Canopy-Solar Shade Footprint and Plans at Stevenson

Kim Reynolds, PACT Foundation

October 1, 2020

Proposed Solar Structures at Stevenson

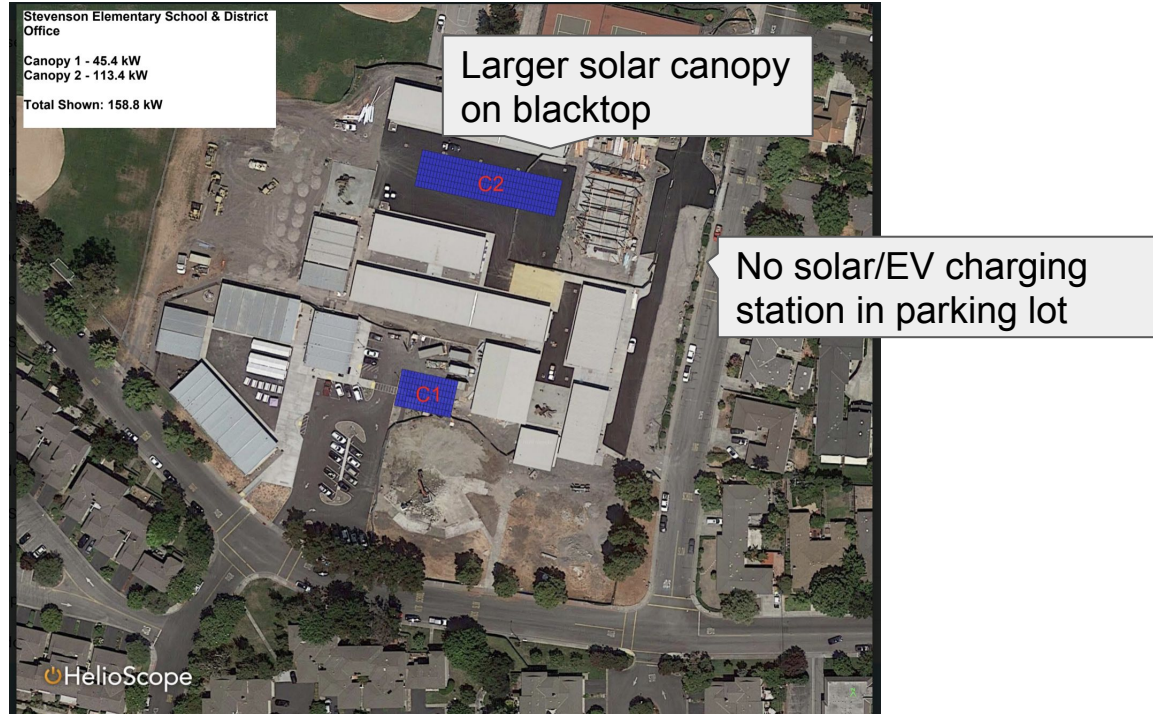
Future position of solar canopy on blacktop

Hooks for student backpacks, with food and water

Tables for snack and lunch

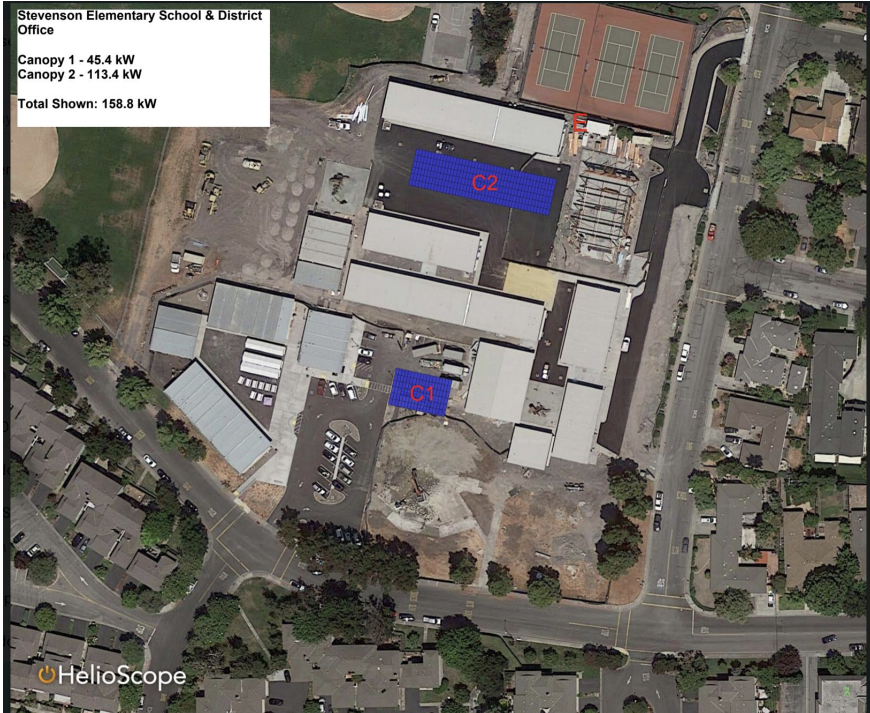
Small overhang at Stevenson doesn't shade backpacks

Hooks for student backpacks, with food and water

The original plans for Stevenson had a larger overhang to shade backpacks.

The larger overhang was cut from the plans due to limited Measure G funding.

Now, student snacks and lunches get too hot in their backpacks and spoil.

Possible Solution: proposal for consideration by Stevenson

- Two canopy-style solar structures and an overhang
 - Similar to September 2020 option
 - 1 on Blacktop to shade lunch tables
 - 1 on Parking Lot with EV Outlets
 - Add an Overhang above Rooms 13-18
- Location, dimensions, and mounting angle of the solar canopy on the blacktop is less critical with overhang
- Leaves more free space for students to play at recess and for future greening or outdoor learning spaces
